Subject: Public Advocates Office's Reply Comments on the Second Revised Draft of Guidelines for the 10-Year Electrical Undergrounding Plans (Revised EUP)

Docket: 2023-UPs

**THE PUBLIC ADVOCATES OFFICE CORRECTED INFORMAL
COMMENTS ON THE APPLICATION OF PACIFIC GAS AND ELECTRIC
COMPANY (U39M) TO SUBMIT ITS 2024 RISK ASSESSMENT AND
MITIGATION PHASE (RAMP) REPORT**

Figure 2. PG&E's Depiction of its Risk Scaling Function (Post-Filing Workshop, Slide 36)

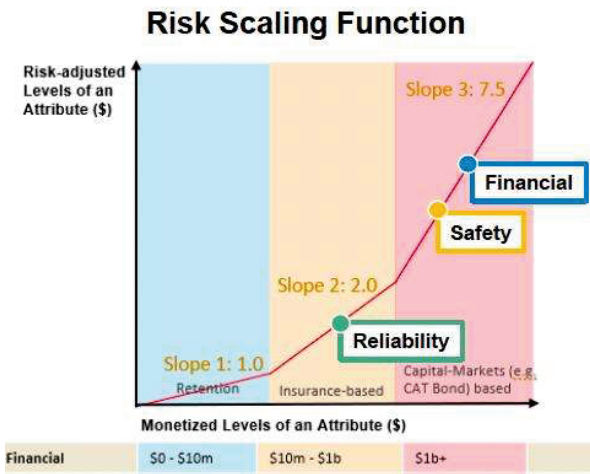
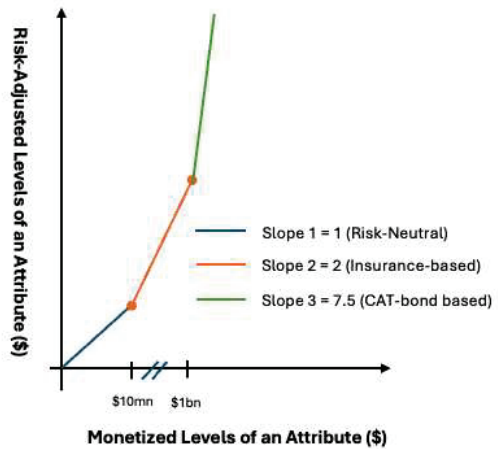
PG&E's graphical depiction of its scaling function (the figure below on the left) is not drawn to scale and masks how drastically it increases consequence values compared to a risk neutral function, particularly in the third risk region, as shown in the to-scale figure on the right.

PG&E has not justified its use of such an extremely convex scaling function compared to a risk-neutral function.

Figure 3. Dollar Damage per Structure Destroyed (Recorded)

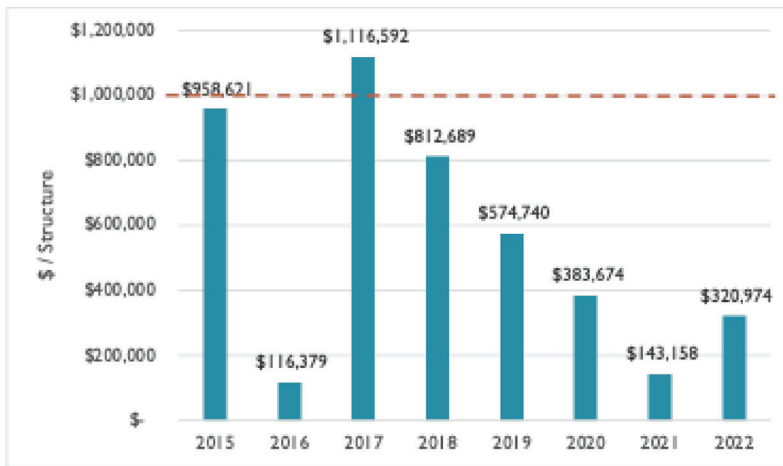
A more realistic assumption that incorporates significantly more data is for PG&E to use the weighted average (by number of structures) from 2015-2022 – approximately \$723,000.³⁹ This is a more accurate and robust estimate than arbitrarily retaining the 2015-2017 weighted average from the 2020 RAMP.

Incorporating this recommendation has a significant impact on the baseline wildfire risk score. **By itself, this change lowers the wildfire risk score by 26% in each year from 2027-2030.**⁴⁰ Making this change would also generally reduce the CBRs for PG&E’s wildfire mitigations as there would be less risk to mitigate for the same cost.

- PG&E should change its wildfire risk assumption of \$1 million per structure destroyed to \$723,000, the weighted average (by structures) from 2015-2022.

Figure 4. Forecast Modeled Customer Minutes of Outage versus Actual Customer Minutes of PSPS Outage, 2021-2023

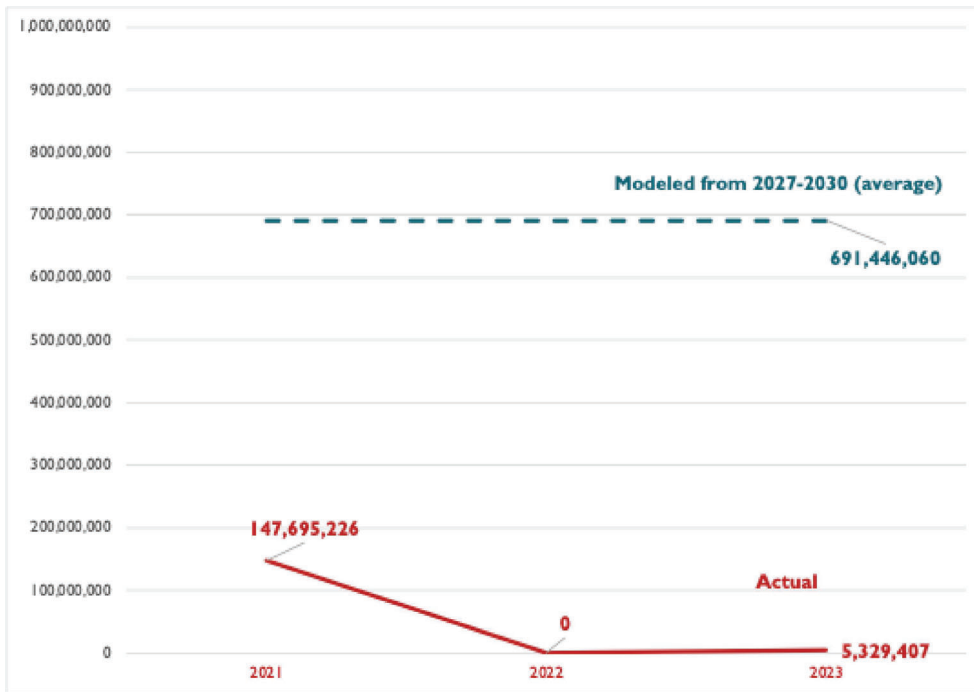
Examination of historical data on the *actual* deployment of PSPS shows that PG&E's methodology significantly overestimates *modeled* PSPS impacts. For example, PG&E's model includes the year 2023, and estimates 722 million customer minutes of outage due to PSPS. Yet the *actual* number of customer minutes of outage in 2023 was only 5.3 million.⁴⁹ This represents a difference of over 13,000%. This discrepancy means PG&E's estimate is simply not realistic or an accurate representation of PSPS outage minutes, as shown in the figure below.

We note that in 2019 and 2020 (not shown in the figure) PSPS customer minutes were above the modeled average; however, we believe these years are not relevant to future forecasts of PSPS outages. First, these years used different PSPS protocols than the one currently in place (the latest was established in 2021).⁵⁰ Second, they do not reflect the operational improvements PG&E has made in implementing PSPS, particularly after 2019 when PG&E unnecessarily implemented PSPS to millions of customers in the midst of its bankruptcy using inadequate operational practices.⁵¹

Figure 6. PG&E Modeling of Baseline Wildfire Risk and Impact of Climate Change

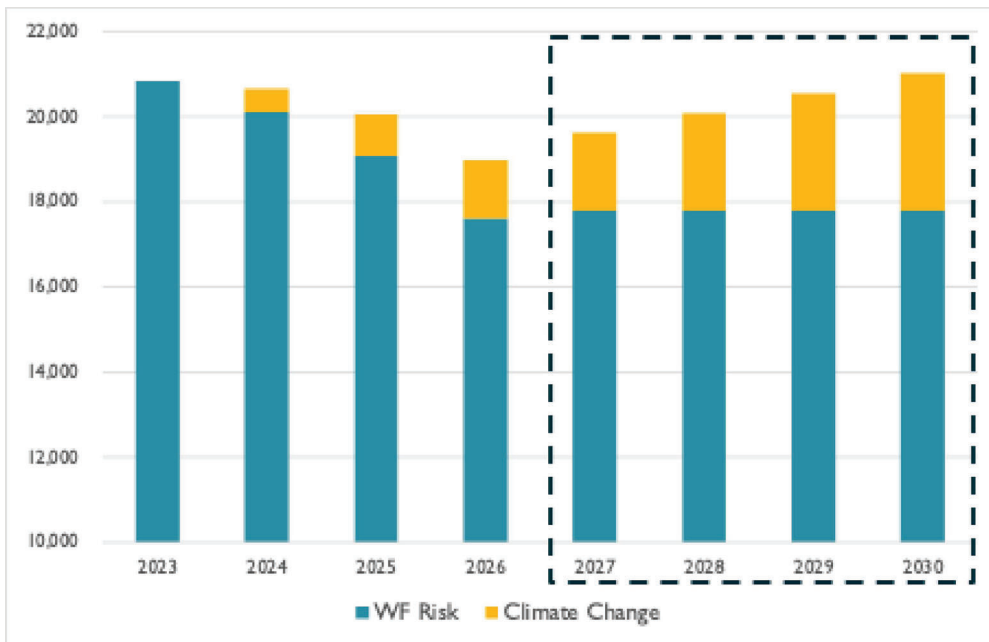
Incorporating climate change has a significant impact on total wildfire risk, comprising 9% of baseline wildfire risk in 2027 to 15% of baseline risk in 2030. Baseline wildfire risk increases by 18% due to climate change from 2023 to 2030.⁵⁹

TURN has identified two issues with PG&E’s climate change calculation.

Figure 7. Annual Impact of Climate Change on Baseline Wildfire Risk Score (Risk Units) ⁶³

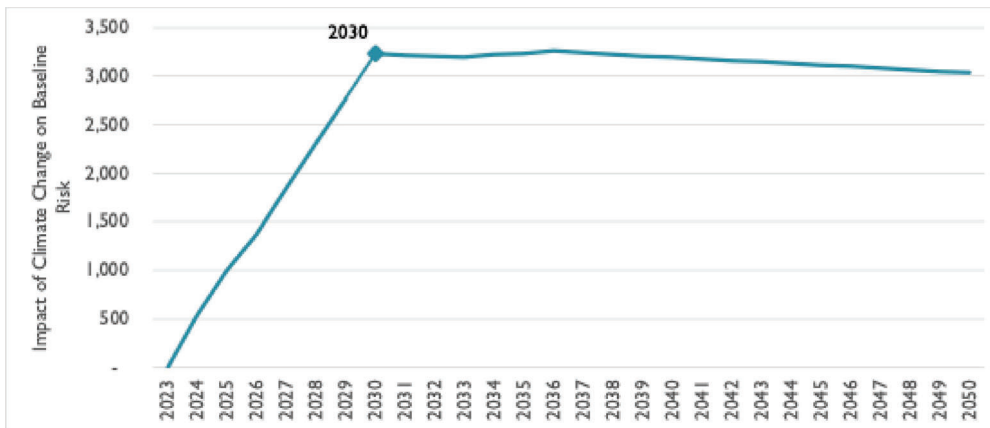
Lastly, ICF’s modeling results are highly counterintuitive. The following figure shows the annual impact of climate change on baseline wildfire risk. Climate change increases baseline wildfire risk at a rising linear rate through 2030, the end of the rate case period, and then has virtually no impact or *decreases* thereafter.

Figure 8. Wildfire Baseline Risk Score (Risk Units, 2023-2050) ⁶⁴

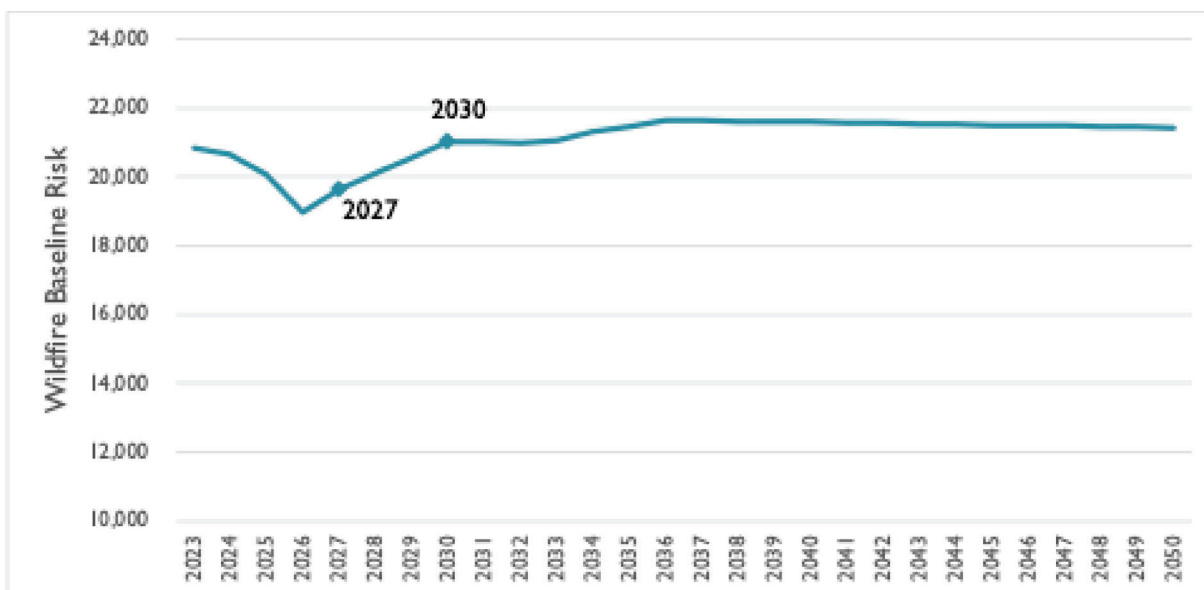
This impact is also seen in the wildfire baseline risk score below, which increases from 2027-2030 and then remains effectively flat thereafter. Note too that the impact of climate change completely erases all risk reduction achieved from 2023-2026 from undergrounding and other initiatives on which PG&E is spending billions and for which ratepayers, particularly those who are lower income, are incurring tremendous hardship.

From a common-sense perspective about climate change, these results do not seem accurate, namely that higher temperatures result in a lower or flat increase in annual risk after 2030. PG&E sought to explain these results as follows:

Figure 9. Alternative Estimate of Annual Impact of Climate Change on Baseline Wildfire Risk Score (Risk Units)⁶⁶

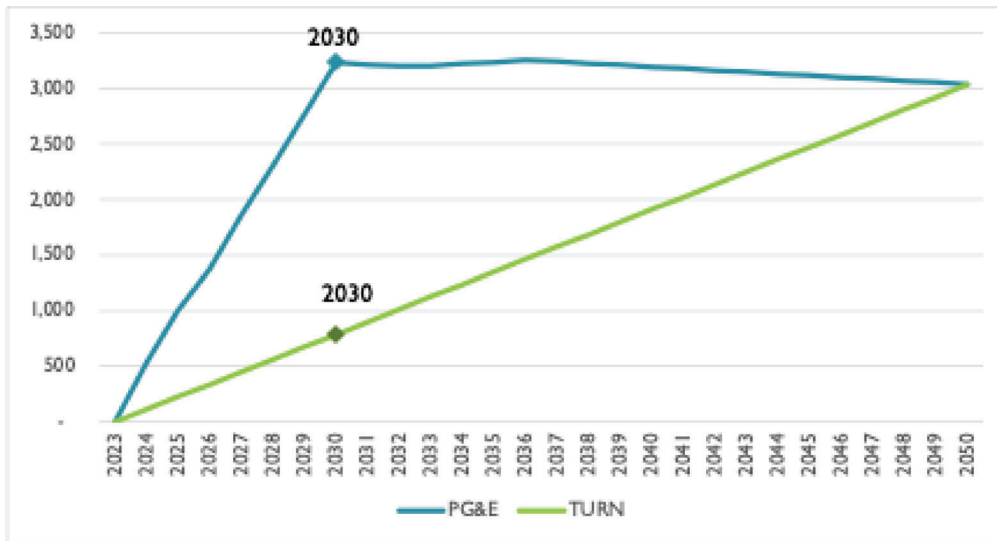
TURN here offers an alternative approach based on the ICF data used by PG&E. Rather than utilizing results whereby all of climate change impacts affect only the 2023-2030 time period, PG&E could incorporate a smoothed average estimate of climate change’s annual impact based on ICF’s results. To accomplish this, we calculate the average impact from 2023-2050 and then set this as the annual incremental amount by which climate change increases the baseline risk score. This approach would allow PG&E to incorporate a more gradual annual increase to the wildfire baseline risk score due to climate change while the Commission and parties explore the topic through a more robust process.

- In modeling climate change impacts, PG&E should incorporate less drastic annual increases for the rate case period in baseline wildfire risk based on its current modeling results while the Commission allows for more robust analysis of the issue in the S-MAP proceeding.
- PG&E conclusion that disadvantaged and vulnerable communities (DVCs) disproportionately benefit from wildfire risk reduction is poorly supported based on the current iteration of its DVC analysis. PG&E's conclusions about benefits to DVCs should be based on a more solid analytical foundation.
